**Historic Preservation
Commission
Decision Letter
Issued: July 20, 2022**

CERTIFICATE OF APPROPRIATENESS

As you are aware, on Wednesday evening the Historic Preservation Commission gave a Final Design Review decision for the work you are proposing for the Jackson-Bailey House & Garage at 1306 W Mountain Ave, approved by motion on a vote of 4 in favor, 2 against, and 1 recusal.

WEST
ELEV.

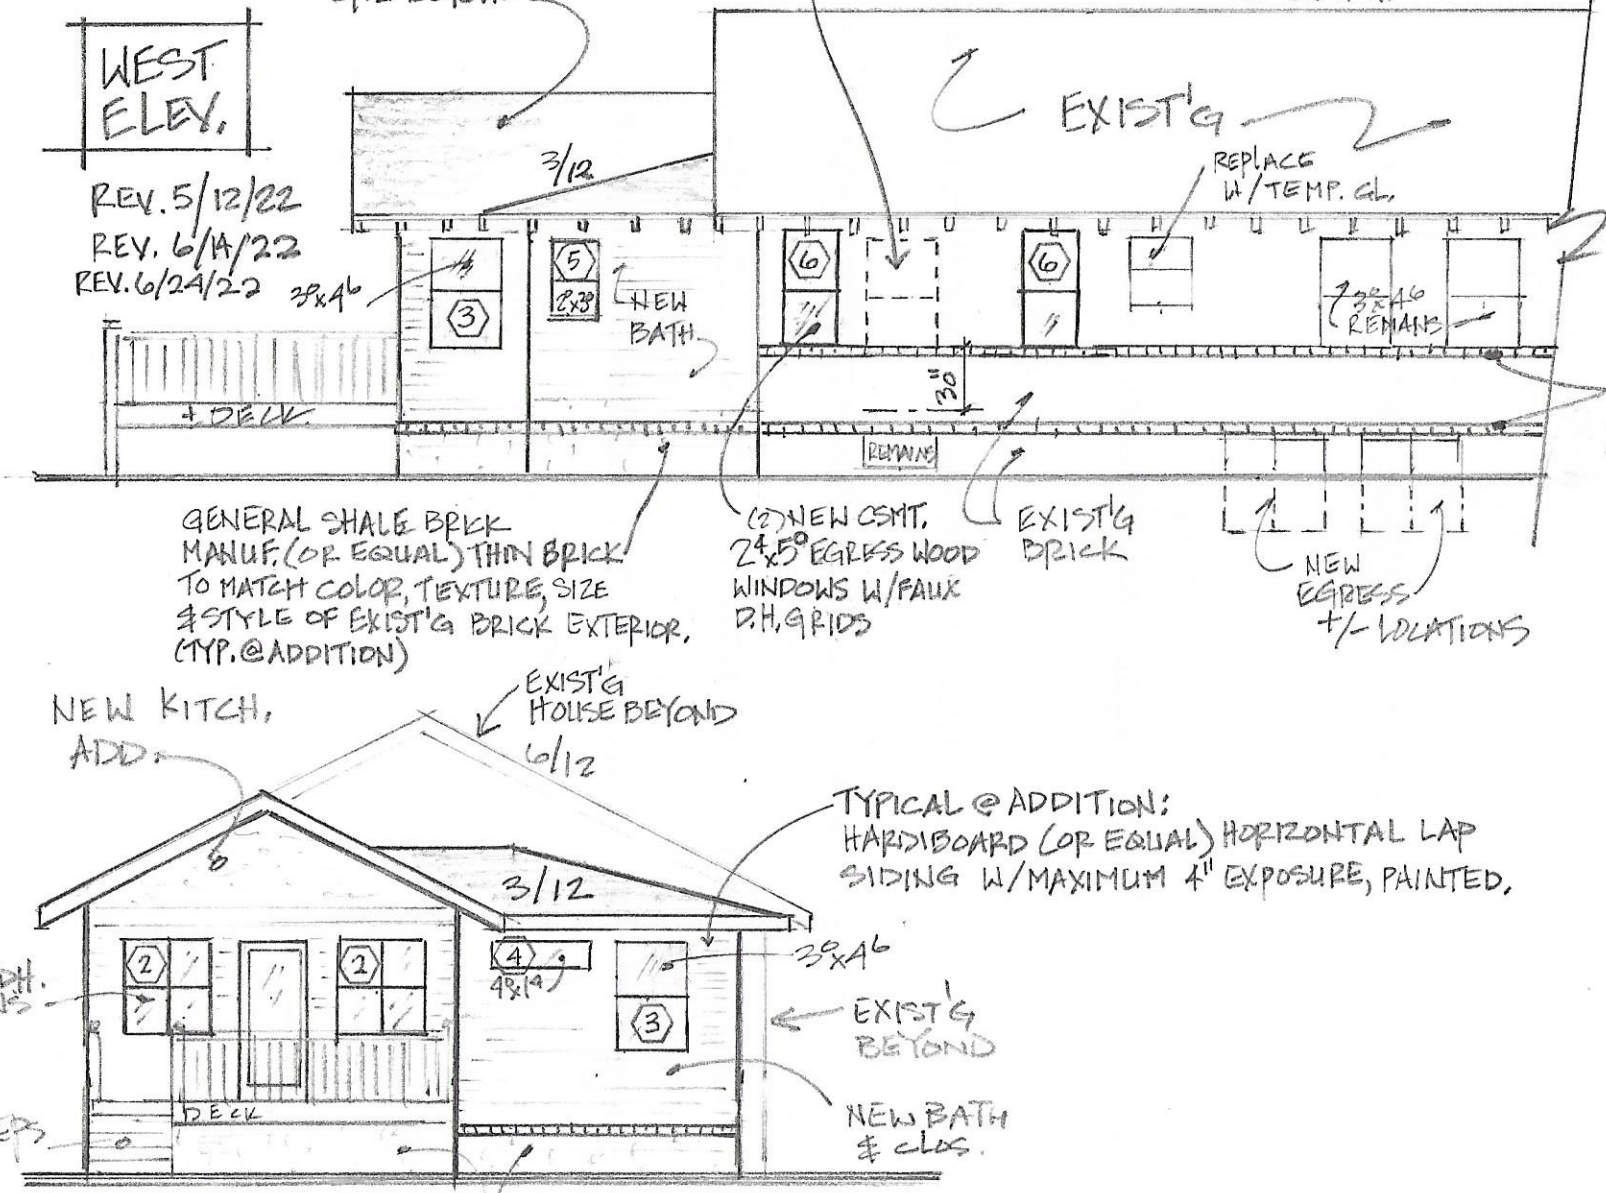
2. Modification of windows on west wall of northwest bedroom on historic house.
 - o Condition: That the window treatment of the northwest bedroom in the historic building be modified to retain the existing window opening, delete one or both of the proposed two new window openings, and install an egress-compliant window in the existing historic opening.

The Commission found that the proposed Item 2, the modification of windows on the west wall of the northwest bedroom on the historic house could meet the criteria and standards in Chapter 14, Article IV of the Fort Collins Municipal Code, provided certain conditions were met, namely retaining the historic window opening and reducing the amount of demolition and infill.
